PRODUCT SAFETY RECALL

SUBJECT: Transmission Shift Cable Fracture

MODELS: 2004-2007 Chevrolet Malibu Maxx
2004-2008 Chevrolet Malibu
2005-2008 Pontiac G6
2007-2008 Saturn AURA
Equipped with 4-Speed Automatic Transmission (ME7/MN5)

1765068

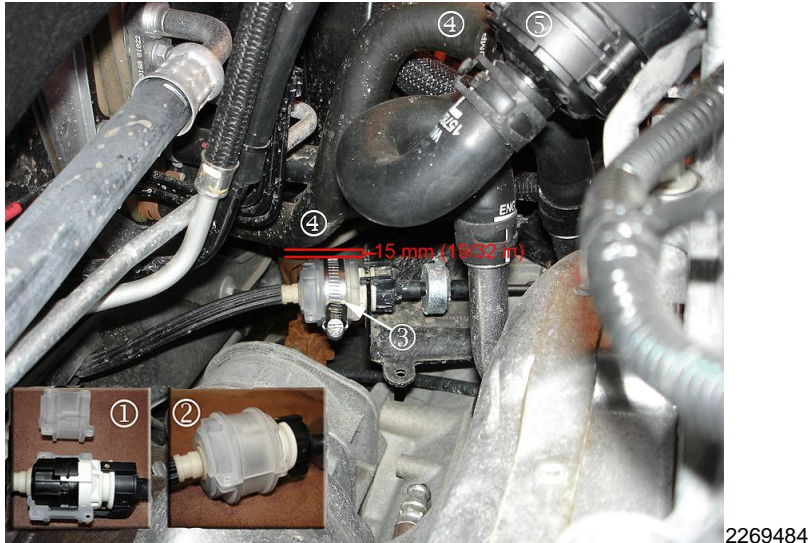
2. Remove and discard the shift cable bracket (4) attached to the transmission.

3. Install a new floor shift control cable and new bracket. Refer to *Floor Shift Control Cable Replacement* in SI.

4. Install the clam shell (1) (2) over the shifter cable locking tabs.
5. Install the service clamp over the clam shell (3). Position the clamp fastener head away from the inlet coolant hose (4). **Tighten the clamp to 4 N·m (35 lb-in).**
6. Ensure that there is 15 mm (19/32 in) of clearance between the inlet coolant hose (4) and the clam shell (3). On hybrid equipped vehicles, it may be necessary to reposition the inlet coolant hose (4) to achieve the required 15 mm (19/32 in) of clearance. **To reposition the inlet coolant hose (4) on hybrid equipped vehicles, locate the heater cooler pump (5) and perform Steps 6.1-6.5.**

Caution: Do not kink or damage the inlet coolant hose (4) when repositioning the hose to obtain the 15 mm (19/32 in) clearance. To avoid damaging the hose clamp, use J-38185 or equivalent hose clamp pliers to loosen the hose clamp.
